Development Review Division

M E M O R A N D U M

SUBJECT: **Parker Central Area McDonald's, Site Plan Amendment**
Review Comments 02

SHEET NO: TO1.0

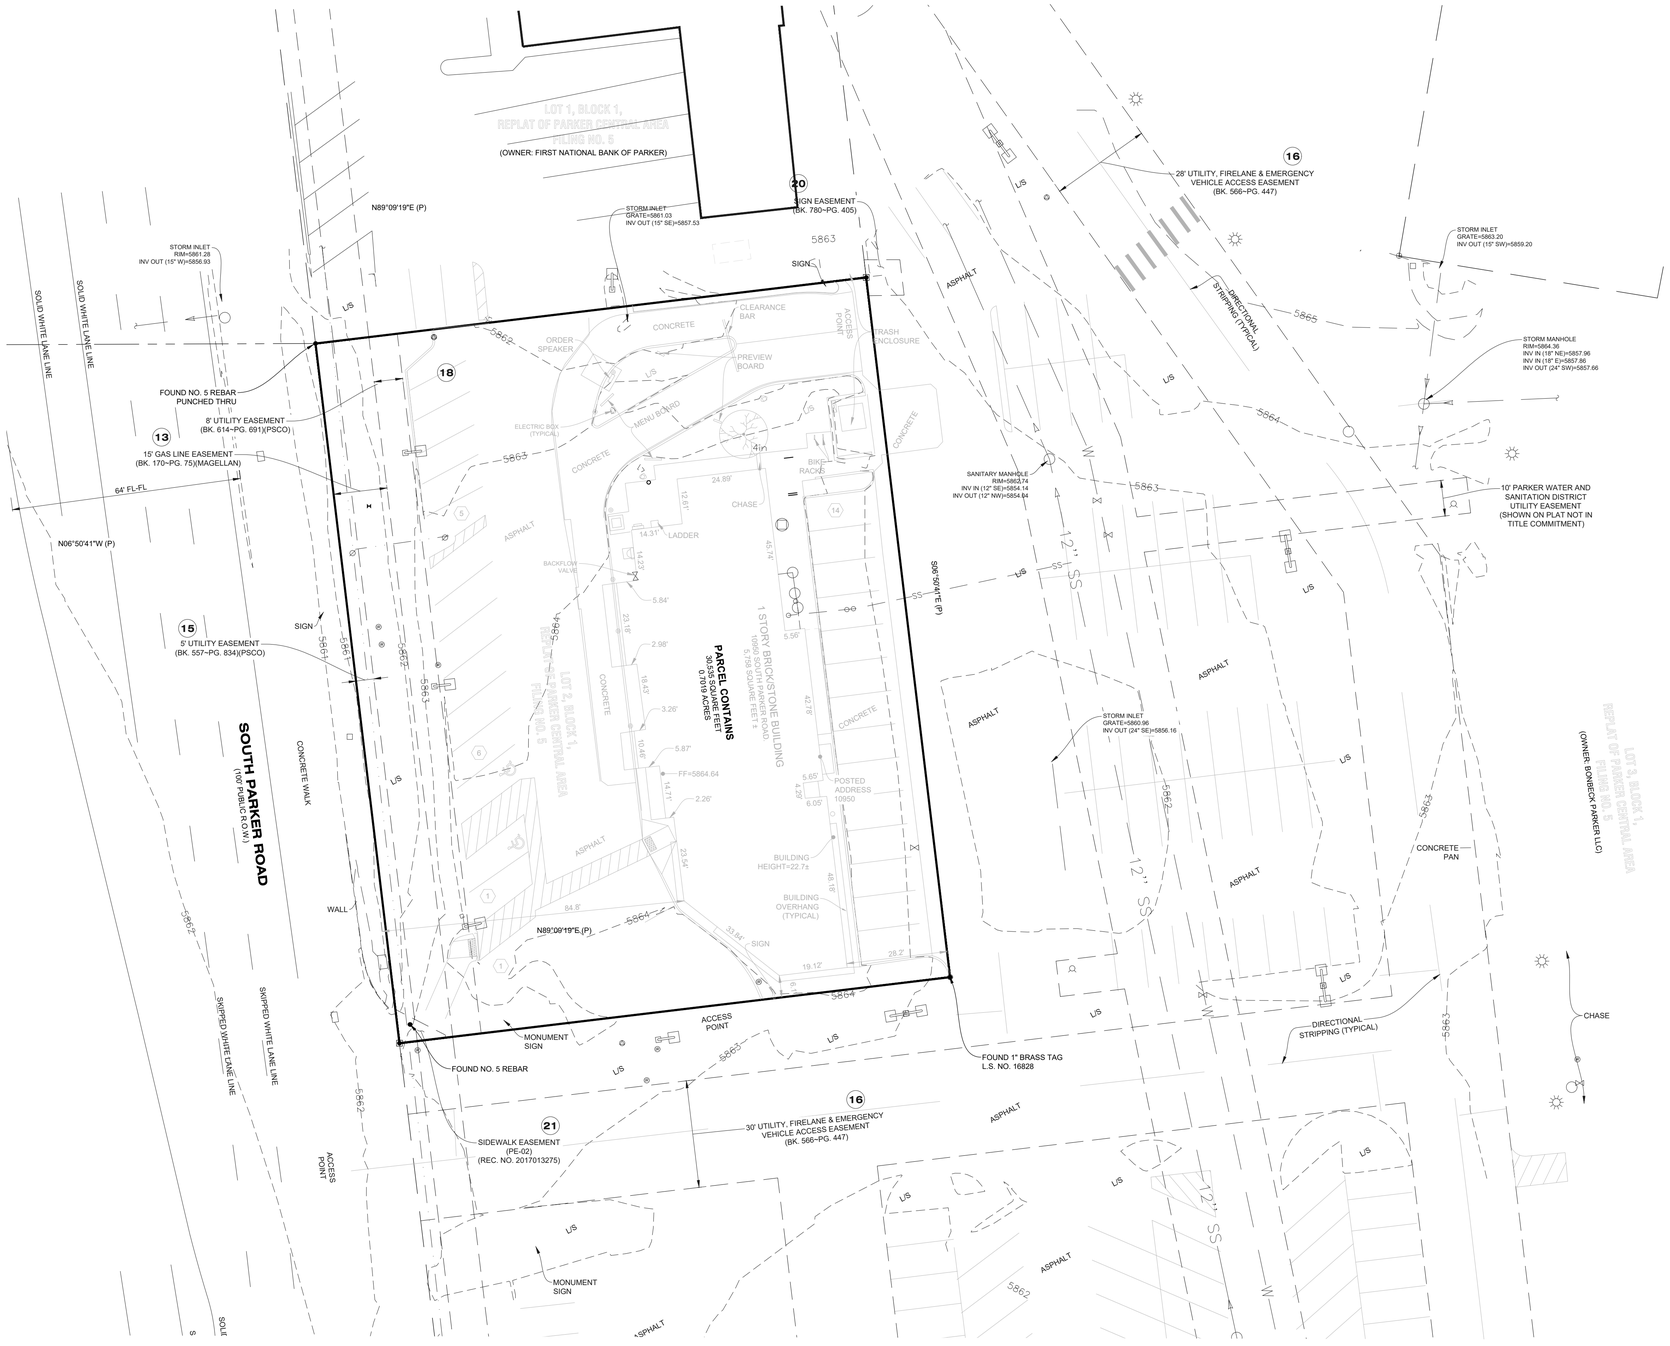
not a PD. zoning is downtown east — REVISED

provide square footage of req/provided — REVISED

1 per 300sf NLA — REVISED

SHEET NO: LI1.0

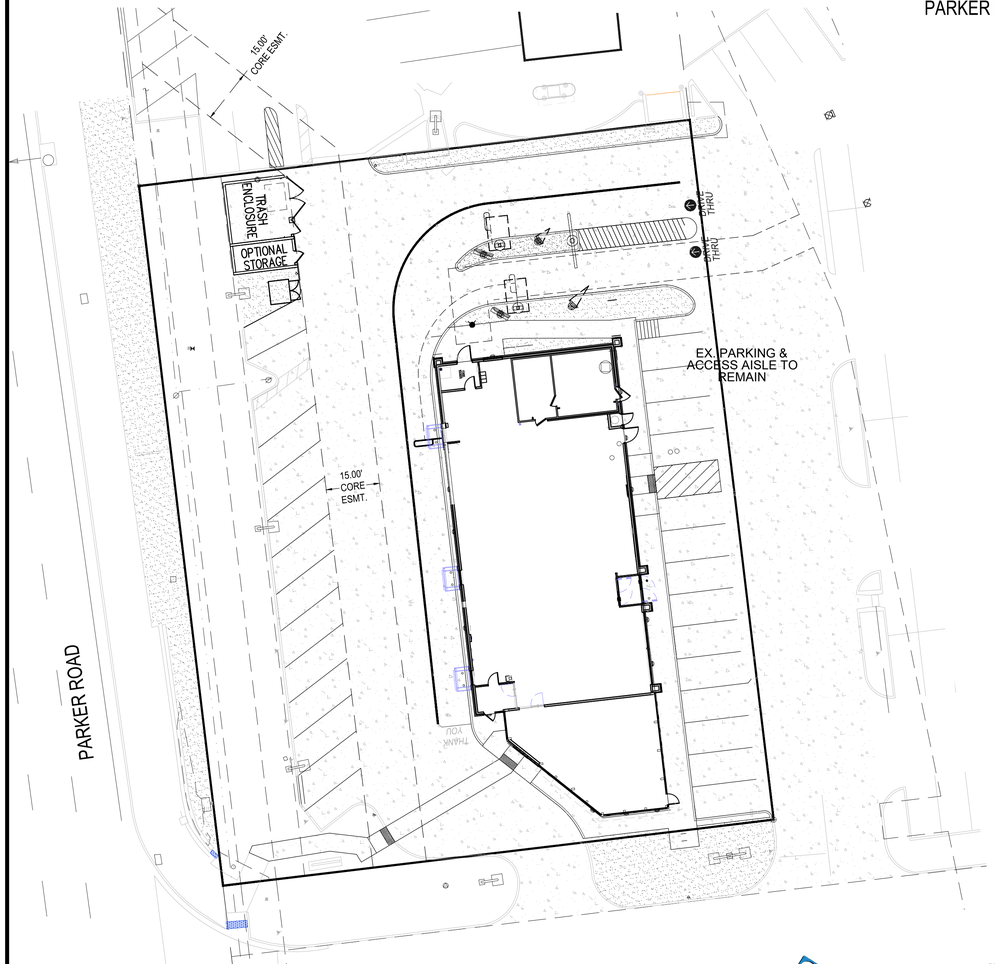
show footcandles on entire site to property lines (max 1.0 footcandles allowed at property lines)

the lighting plan is updated and new lot lights are installed utalizing LED and meeting the property line requirements.

SHEET NO: LS1.0

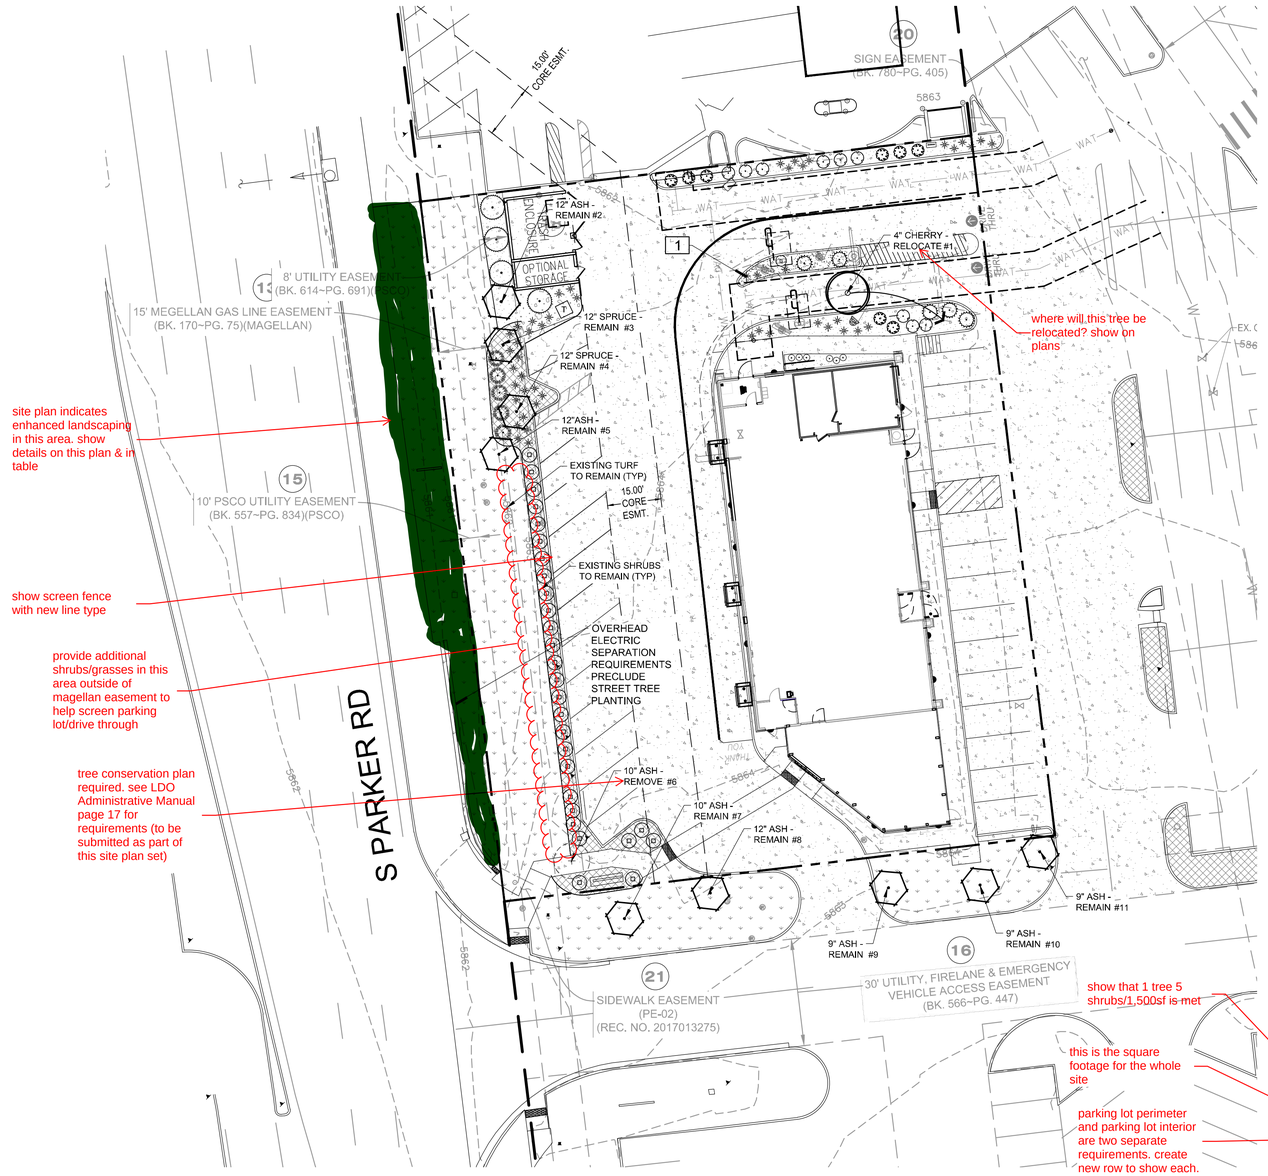
7 trees not listed in plant schedule as proposed.

31 shrubs proposed in plant schedule

provide square footage for req/provided

show that 1 tree 5 shrubs/1,500sf is met

parking lot perimeter and parking lot interior are two separate requirements. create new row to show each.

use this section to show "enhanced landscaping" as noted on site plan

no proposed trees in schedule or in drawing

SHEET NO: IRR1.0

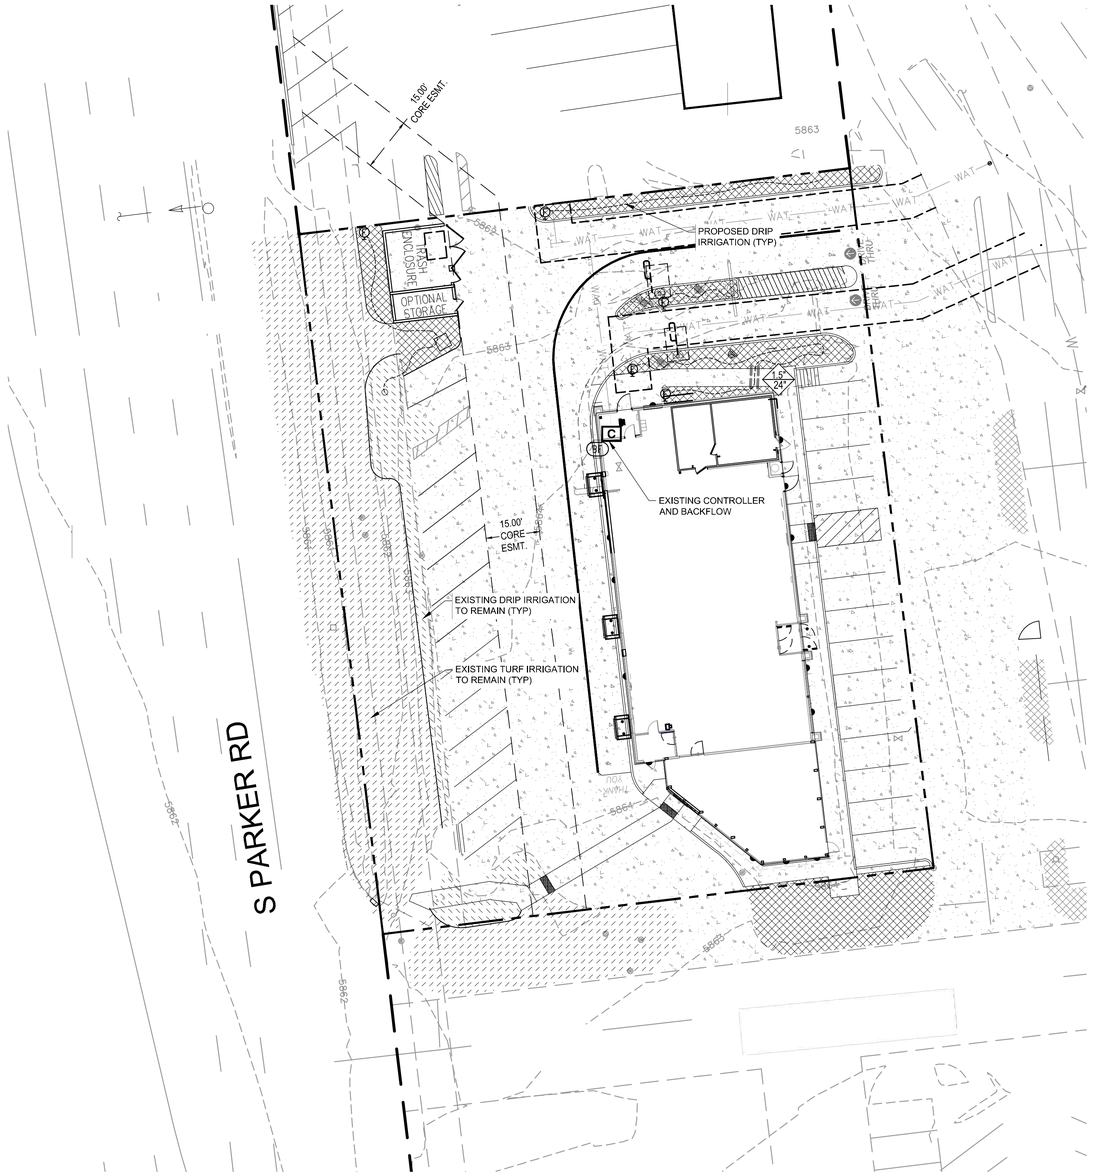
Provide seperate 1" wire sleeve along all all mainline crossings, of equal length to length of pipe sleeve

DRAWING NO:
A2.01

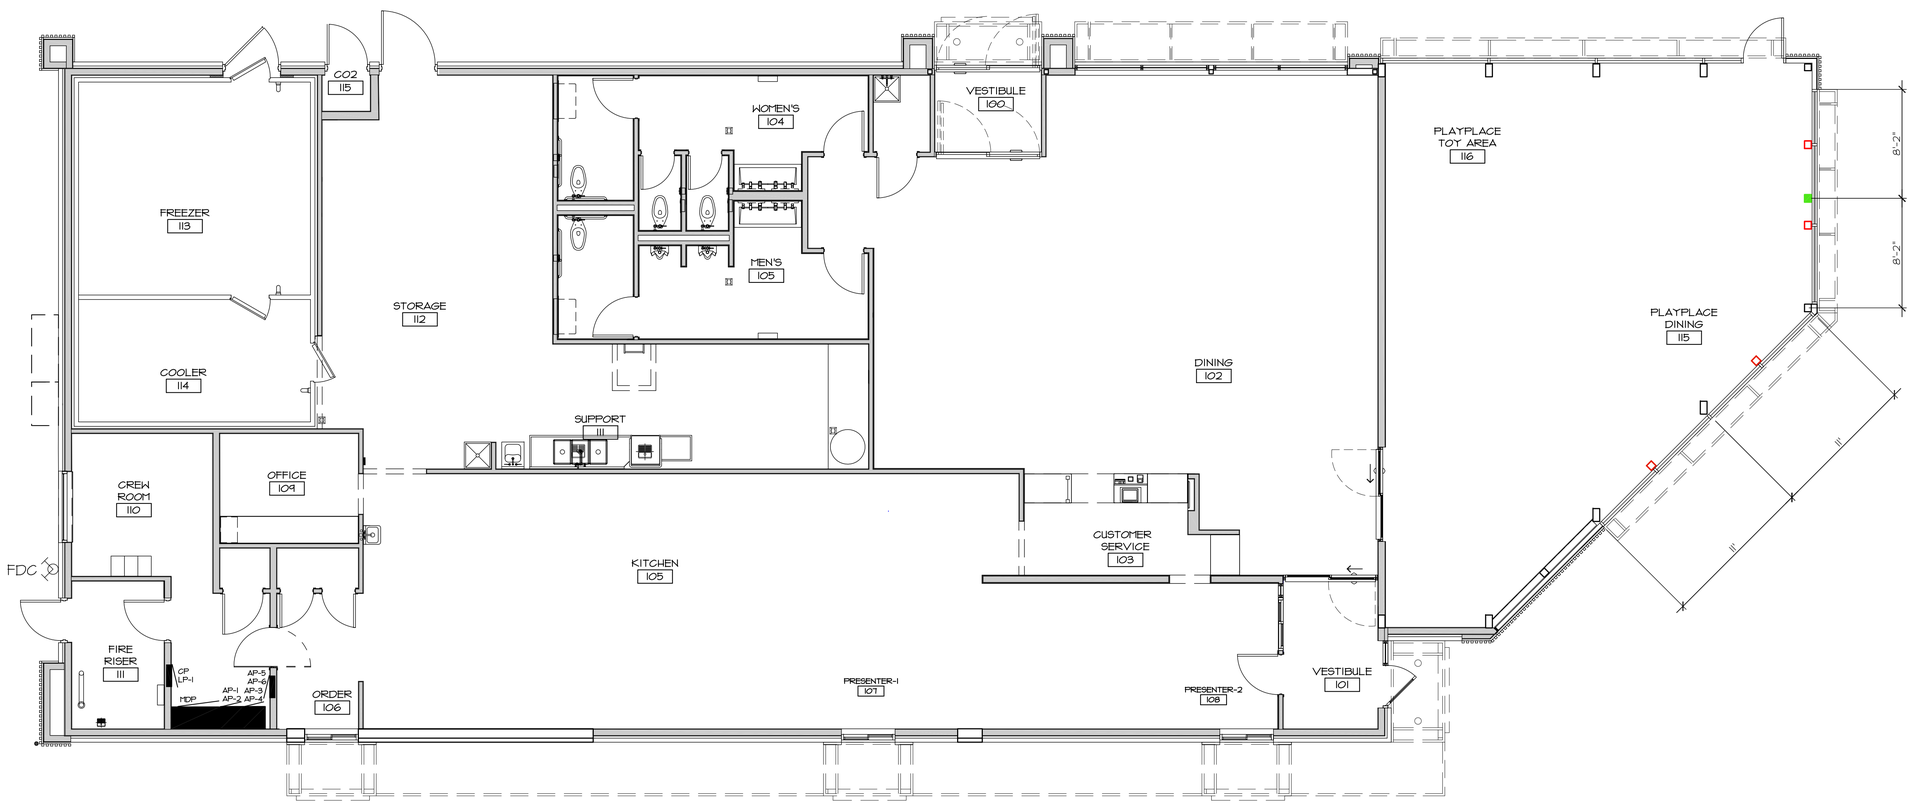
transparency calculations for all facades needed

show wall-mounted electrical equipment, add note that it will be painted to match adjacent wall

DRAWING NO:
A3.01

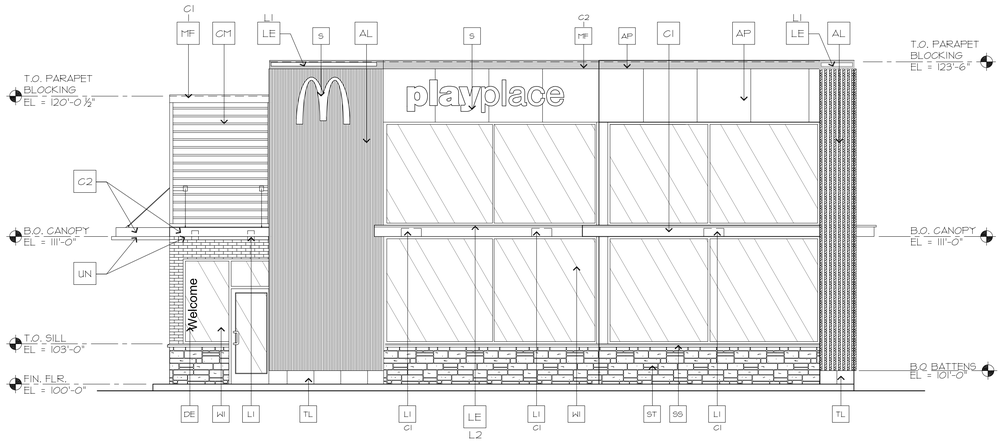
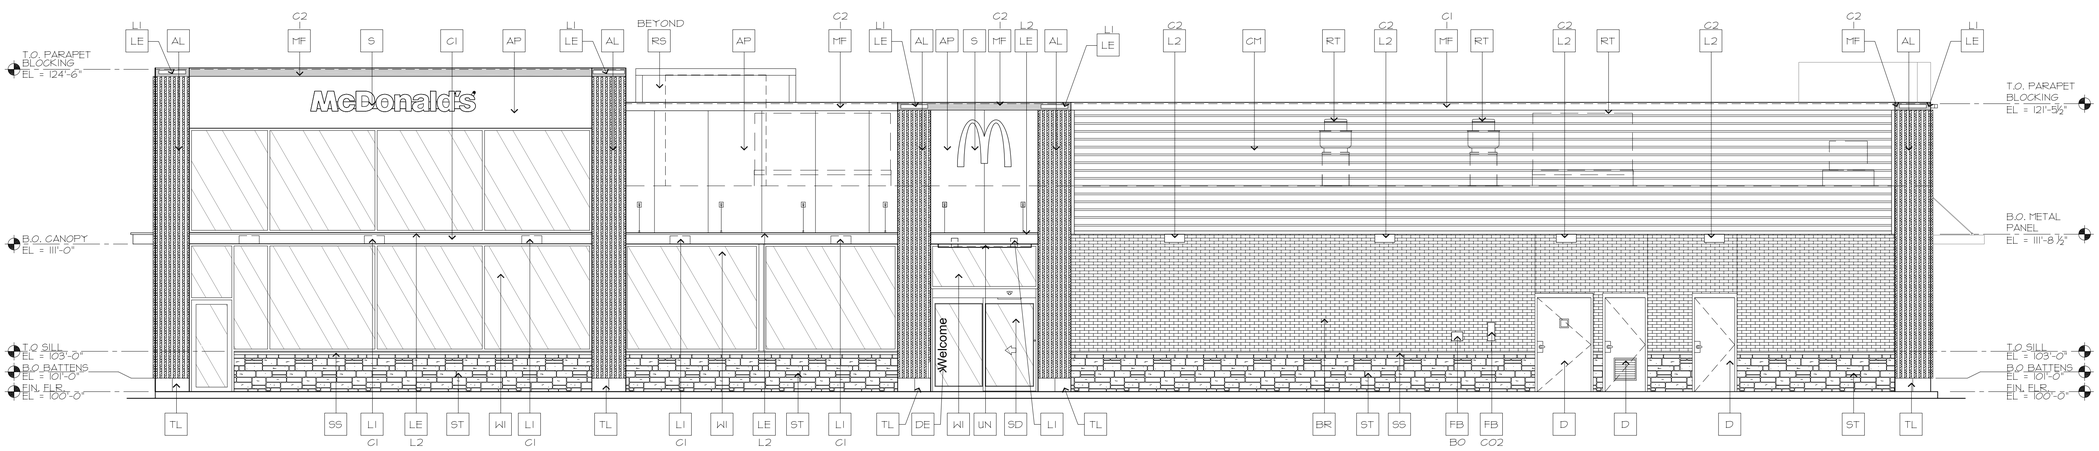
west

show guard rail on elevations and site plan

DRAWING NO:
A3.02

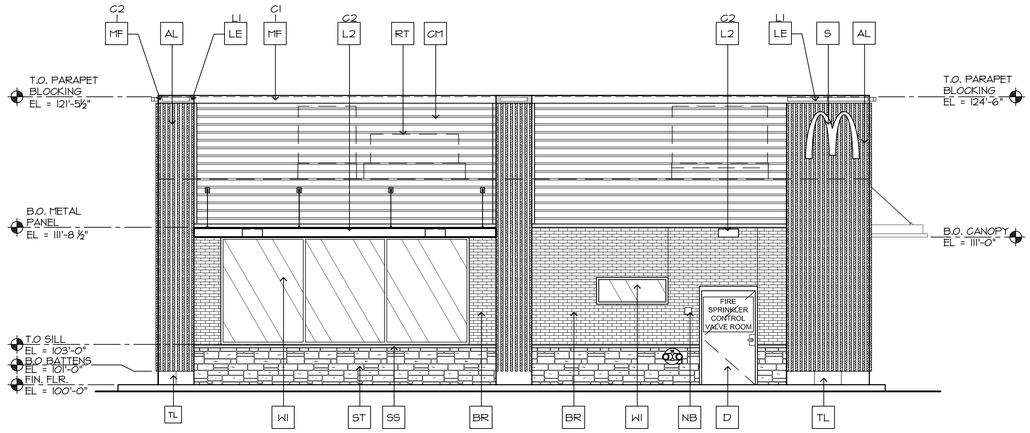
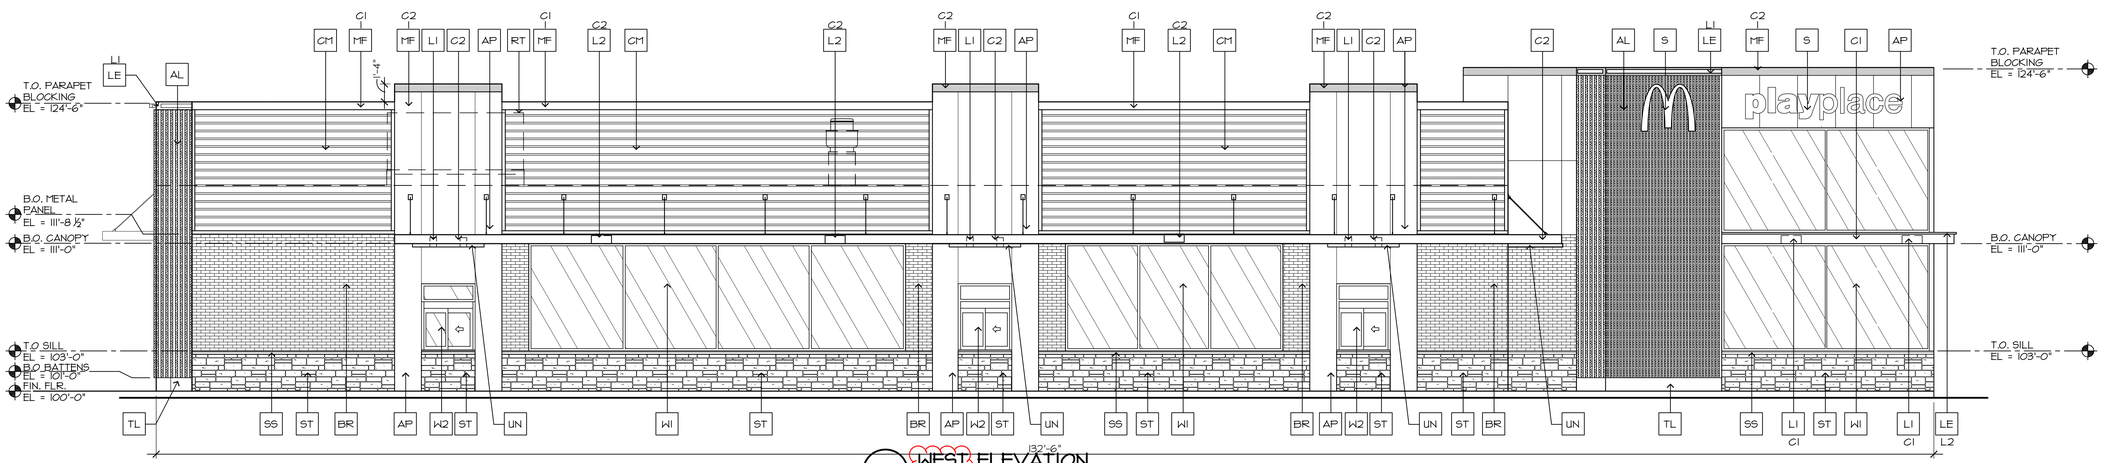
east
